YEAR/MODEL ANNÉE/MODÈLE	DATE OF ISSUE DATE EN VIGUEUR	BULLETIN NUMBER NUMÉRO DU BULLETIN
1993~1995 DEL SOL	JAN. 13/1995	IV-1-95

BURNED ~OUT AUXILIARY LIGHT

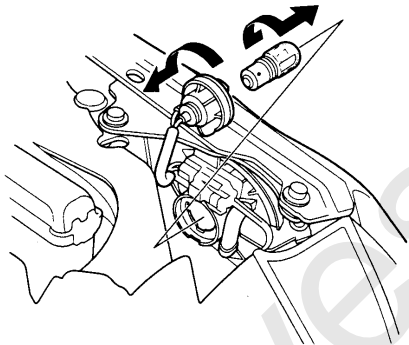
Some owners of 1993~1995 Civic Del Sol's may complain of one or both auxiliary lights burning out prematurely. To correct this problem replace the bulbs in both auxiliary lights (even if only one is burned out) with the improved bulbs, listed in Parts Information.

Note: Replace both bulbs even if only one has burned out.

1. Open the hood.
2. Remove the socket from the lamp by turning it one-eighth turn counterclockwise.
3. Remove the bulb from the socket and install the new bulb.
4. Reinstall the socket in the lamp.
5. Repeat steps 2 through 5 on the other auxiliary light
6. Test the bulbs by turning on the headlights (low beam) and the auxiliary lights.
